AGENDA ITEM: 7 AGENDA DATE: 1/16/2025

SECOND ADDENDUM TO THE TECHNICAL STAFF REPORT

SUBJECT: McDonald's Ager Road — DSP-22001 and TCP2-004-2024

Figure 1. Internal Traffic Calming Elements

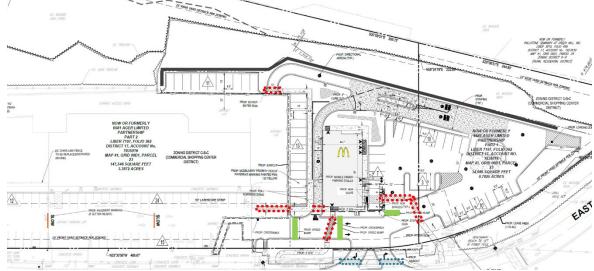
To reduce the speed of entering vehicles and protect pedestrians from the existing on-site traffic, high-visibility traffic calming elements are proposed within the site. As shown in the figure below, additional pavement markings, crosswalks (highlighted in red), and speed bumps (highlighted in green) were added near the driveway entrances and along the drive aisle to the east of the proposed building.

Figure 2. Proposed Crosswalks and Sidewalk

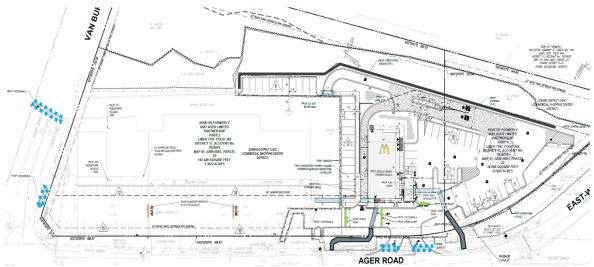
- b. **Pedestrian circulation:** To improve pedestrian access and connections to the shopping center, including the proposed standalone pad site building, additional striped crosswalks are planned at several key locations. These include (*See illustration below*):
 - The northern edge of the property, north of the intersection of Van Buren Street and Ager Road
 - East of the existing building
 - At the drive-through exit

- Along the western edge of the property
- Near the southernmost driveway, close to the existing crosswalk across MD 410 (East West Highway)

Figure 3. Drive-through Queuing

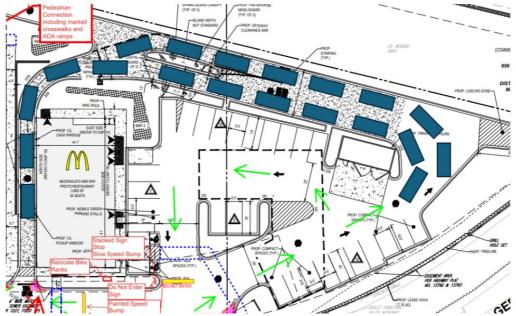
c. **Drive-through queuing analysis:** Exhibit 3 includes a queuing analysis submitted by the applicant for the drive-through lane portion of the proposed development. As shown below, the plan allows for approximately 12 to 14 vehicles in the double drive-through lanes, from the order lane to the drive-through entrance, and additional space is available to accommodate 6 more vehicles between the pickup window and the order board. More importantly, the illustration shows that, according to Section 27-274(C)(6) of the prior Zoning Ordinance, the design of the drive-through does not conflict with circulation traffic patterns or pedestrian access.

Figura 1. Elementos internos para calmar el tráfico

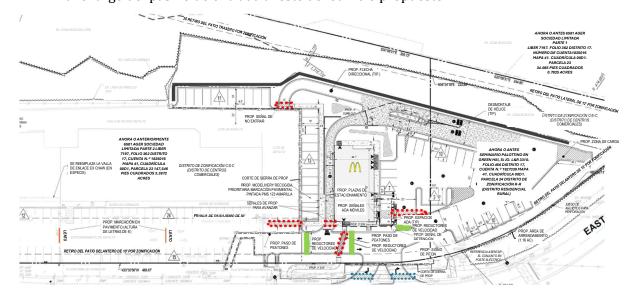
Para reducir la velocidad de los vehículos que ingresan y proteger a los peatones del tráfico existente en el lugar, se proponen elementos de calmado del tráfico de alta visibilidad dentro del sitio. Como se muestra en la figura siguiente, se agregaron marcas en el pavimento, cruces peatonales (resaltados en rojo) y reductores de velocidad (resaltados en verde) cerca de las entradas de vehículos y a lo largo del pasillo de entrada al este del edificio propuesto.

Figura 2. Propuestas de pasos de peatones y aceras

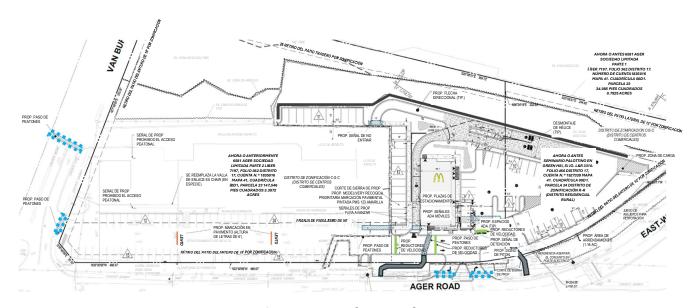
b. **Circulación peatonal**: Para mejorar el acceso peatonal y las conexiones con el centro comercial, incluido el edificio independiente propuesto para el sitio de la plataforma, se planean cruces peatonales rayados adicionales en varios lugares clave. Estos incluyen (*Ver ilustración a continuación*):

- El borde norte de la propiedad, al norte de la intersección de Van Buren Street y Ager Road
- Al este del edificio existente
- En la salida del autoservicio
- A lo largo del borde occidental de la propiedad
- Cerca del camino de entrada más al sur, cerca del cruce de peatones existente en MD 410 (East West Highway)

Figura 3. Colas para autoservicio

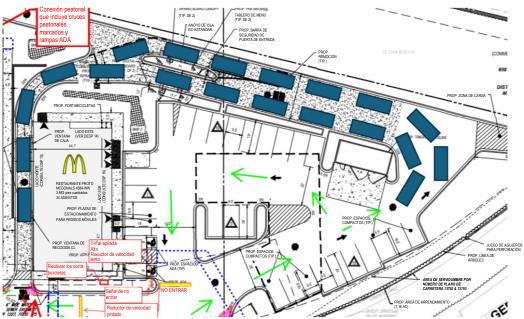
c. Análisis de colas de autoservicio: El anexo 3 incluye un análisis de colas presentado por el solicitante para la parte del desarrollo propuesto con carril de acceso vehicular. Como se muestra a continuación, el plan permite aproximadamente de 12 a 14 vehículos en los carriles dobles de acceso desde el carril de pedidos hasta la entrada de autoservicio, y hay espacio adicional disponible para acomodar 6 vehículos más entre la ventana de recogida y el tablero de pedidos. Más importante aún, la ilustración muestra que, de acuerdo con la Sección 27-274(C)(6) de la Ordenanza de Zonificación, el diseño del acceso vehicular- no entra en conflicto con los patrones de tráfico de circulación o el acceso peatonal.
